Bridge Design Engr.	M:\PRELIMINARY PLANS\I-5 EVERETT HOV LANES\BRIDGE 5-633 E\5-633E TYPICAL SECT.MAN								
Supervisor	2/5/05	ADDENDUM #5			REGION NO.	STATE	FED. AID PROJ. NO.	SHEET NO.	TOTAL SHEETS
Designed By					10	WASH.			
Checked By					JOB NUMBER				
Detailed By Andersen, JM 07/04									
Bridge Projects Engr.									
Prelim. Plan By Hsieh, JC 07/04									
Architect/Specialist	DATE	REVISION	BY	APP'D

I-5 EVERETT
SR 526 TO SR 2 HOV LANES

GNRY 36TH ST OC BRIDGE NO. 5/633E WIDENING

BRIDGE SHEET NO. 3

TYPICAL SECTION NEAR PIER 8

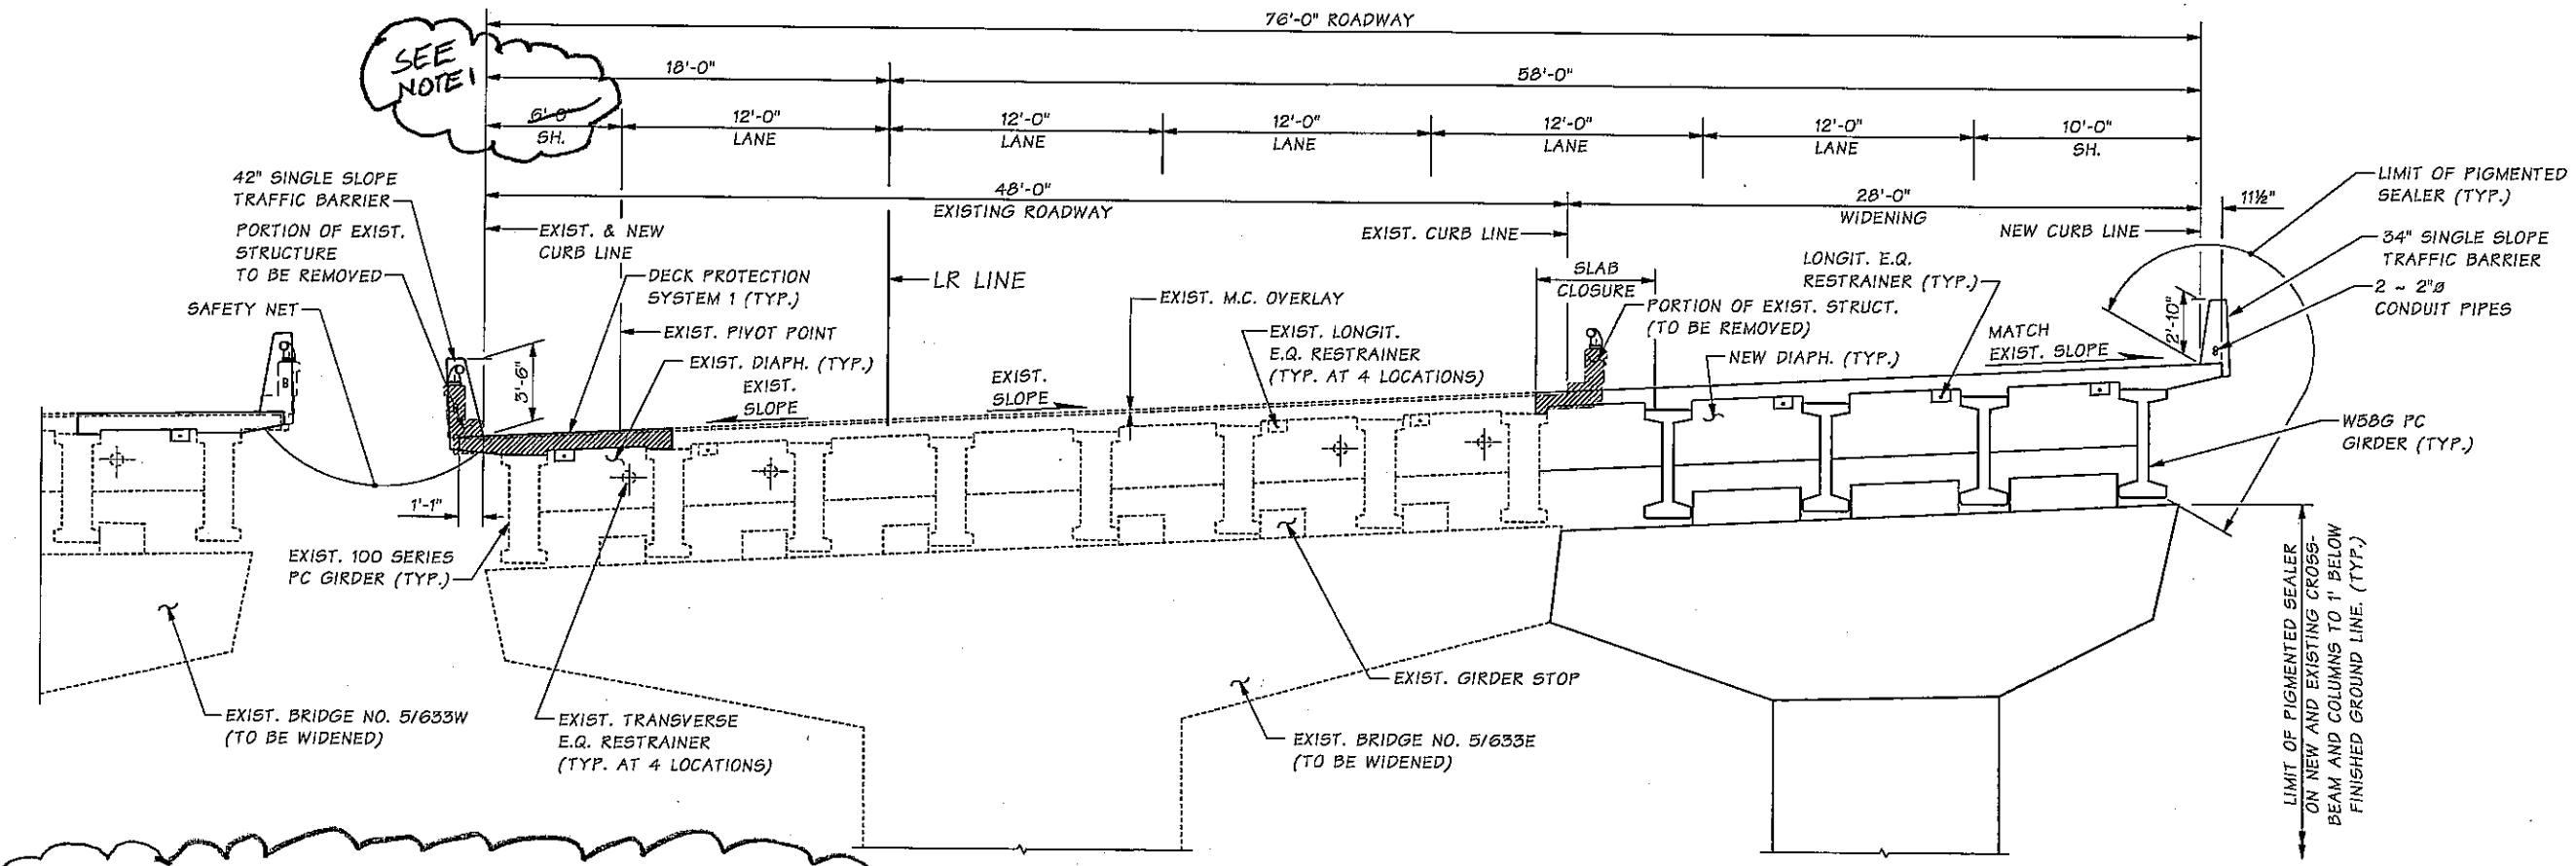
NOTE 1: WSDOT CONCEPTUAL DESIGN OF 5/633E INCORRECTLY INDICATES A 6'-0" INSIDE SHOULDER. DESIGN-BUILDER SHALL CORRECT THIS TO 8'-6" TO COMPLY WITH THE APPROVED DEVIATION IN APPENDIX M3.
